Federal Motor Vehicle Safety Standards

ACTION: Denial of Petition for Rulemaking.

SUMMARY: This document denies a petition for rulemaking submitted by Mr. Richard T. Ince of C & J Technology Inc., to amend provisions of the Federal motor vehicle safety standard (FMVSS) for rearview mirrors pertaining to the test procedure for school bus driving mirrors.

Figure 1. Ince Exhibit B.

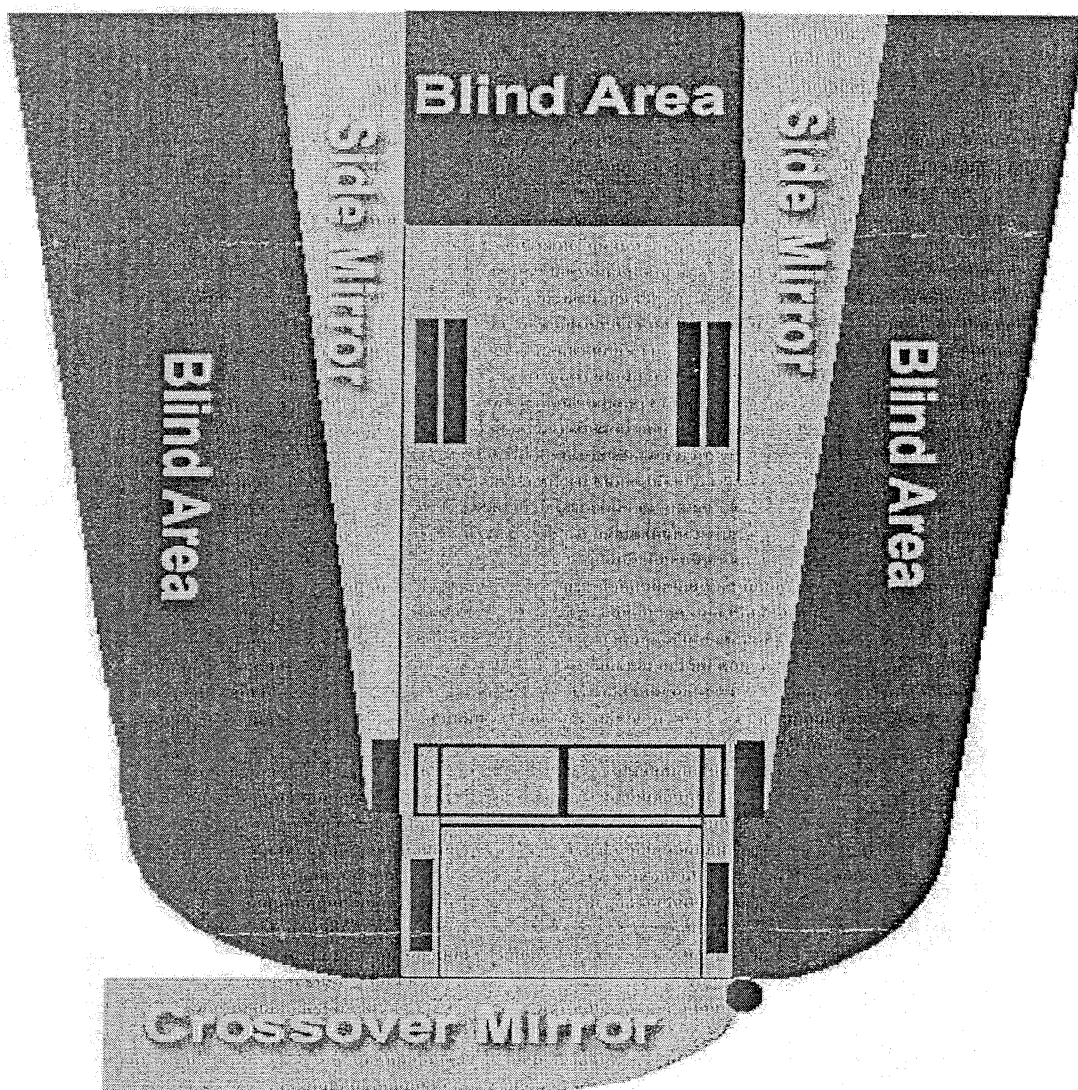
On June 2, 2004, the agency received a petition from Mr. Richard T. Ince, C & J Technology Inc., requesting that the agency review and amend paragraph S13.3(g) of FMVSS No. 111, "Rearview Mirrors," which provides procedures for the placement of "cones" "P" and "L" in the school bus mirror test procedure for the driving mirrors. The petitioner stated that the change is needed "because the rule as stated provides unnecessary and dangerous blind spots in the operator's field of indirect vision along the sides of the school bus."

specified height and size at various locations around the school bus. He said cylinder P on the passenger side of the vehicle is placed at 3.6 meters (12 feet) to the right of the longitudinal vertical plane tangent at the center of the rear axle. He said that cylinder L on the driver side, is placed at 1.8 meters (6 feet) to the left of the longitudinal vertical plane tangent at the center of the rear axle. The petitioner asserted that meeting such requirements "builds into the vehicle blind spots along the sides of the vehicle that are unnecessary and dangerous," and he illustrated this with an Exhibit B (Figure 1). C & J Technology claims that these blind spots put the operator and any children along the sides of the vehicle in a dangerous position as the bus leaves a stop, because the driver cannot see the blind spot areas in the rearview mirror system. The petitioner claims that in such situations the driver would be forced to physically look at these areas before moving the bus forward; however, if the driver does not, it could be especially dangerous to children in these blind spots.

C & J Technology's recommended solution is to amend the standard so that cylinders L and P are moved out from the center of the rear axle to a point that would reduce or eliminate the alleged blind spot problem. The petitioner stated that with the use of the "BDS Dead Angle Spot Mirror," the field of vision could increase to a level up to 65 percent greater than that provided by the standard's current requirements. The petitioner further stated that the "BDS Dead Angle Spot Mirror" is a wide angle glass, and it is cut in such a manner as to make it possible to move the cylinders out to approximately 21.4 meters (70 feet) from the center of the rear axle, thereby making "the entire side of the bus visible with just a glance in the mirror by the operator."

The statement provided by C & J Technology, which asserts that the test procedure requirements in the standard builds into the vehicle dangerous blind spots, is inaccurate. Currently, all school buses are required to have two mirror systems, System A mirrors that are typically called "driving mirrors," and System B mirrors which are pedestrian detection mirrors. The System A mirrors are used by the operator to maneuver the school bus safely in traffic. The System B mirrors are pedestrian detection mirrors that are

Figure 2, Minimum viewing area, School Bus System A and B Field-Of-View

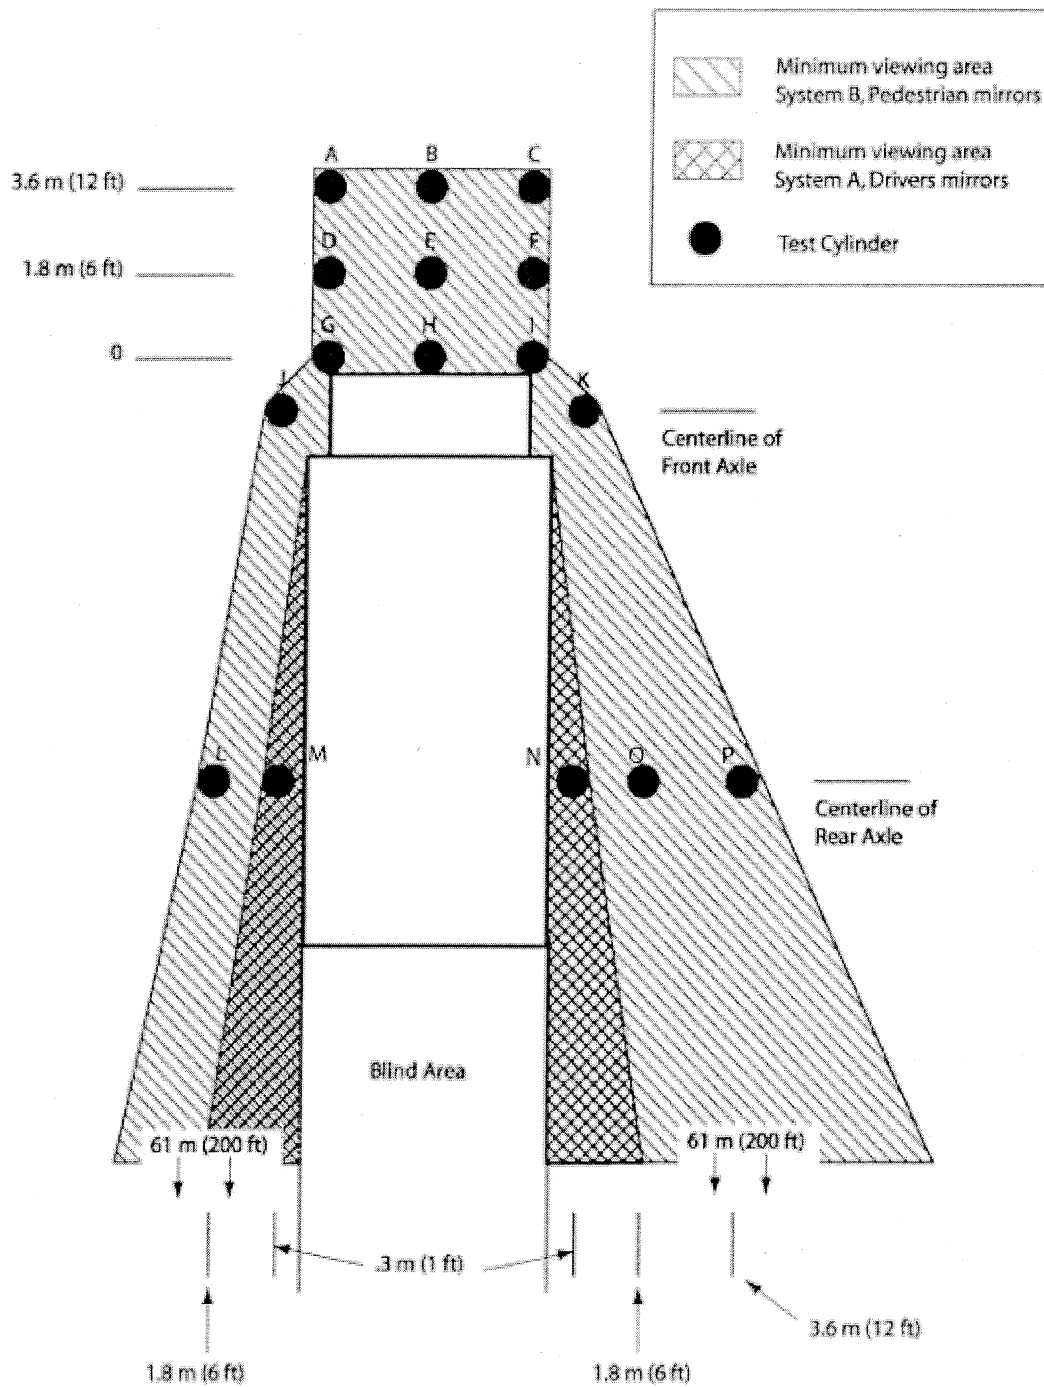
in order to ensure that there are no blind spots. Figure 2 presents a graphic with the minimum viewing areas required by the standard. The petition asserts that the System A driving mirrors may not serve as adequate pedestrian detection mirrors. Even accepting this as true, the driving mirrors are not intended to serve as pedestrian detection mirrors.
